**ATCO Electric Yukon (AEY) & Yukon Energy Company (YEC)
2025 Terms & Conditions of Service**

**Information Responses Round 1 to:
The Yukon Utilities Board (YUB)
Received: February 28, 2025**

Issue: Study on Maximum Investment Levels (MILs or MILs Study) – Company Investment: Proposed vs. Approved MILs

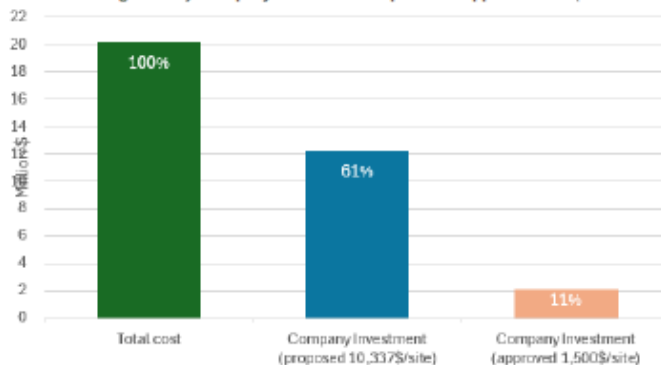
In its examination of the graphs provided by AEY which show, for each category of MIL proposed, the “Company Investment: Proposed vs. Approved MILs,” the Board is unable to replicate certain costs provided by AEY that inform AEY’s calculation of the company investment as a percentage of the total cost. The Board understands these costs are representative of 1,437 sites in the case of Residential Single Family as can be found in Appendix B, tab “Residential Single Family.”

However, the Board is unable to confirm the total company investment of \$12,259,246 by taking the proposed MIL of \$10,337 per site x 1,437 sites which equals \$14,854,268. When \$14,854,268 is taken as a per cent of the total cost of \$20,226,300 the result is 73 per cent. This is in contrast to AEY’s results which show that a proposed MIL of \$10,337 x 1,437 sites equals a total company investment of \$12,259.636, or 61 per cent.

- (a) Please respond to the Board’s observations as noted in the preamble for each of the four MIL categories by explaining AEY’s derivation of its proposed MIL and the corresponding calculation of company investment in dollars and as a percentage of total costs in (inflated) 2025 dollars. Please show all mathematical calculations in support of AEY’s response.

- (b) Does paragraph 19 on PDF page 98 as quoted above provide for a comparison of equivalent-type costs? For example, is there a difference between recovering “61 per cent of the **total costs being invested by the utility**” and “only 11 percent of **the average connection’s total costs?**” [emphasis added]
- (c) Please provide the approved company investment percentages approved in AEY’s previous MIL related application for each of the four MIL categories?
- (d) Referring to 2024-12-20 Appendix B - MILs Study – Excel, tab “General Service” please identify and fully explain the source and derivation of the inputs with respect to the “MIL, 2011\$” in the amount of \$1,394² found at Row 14, Column AM.
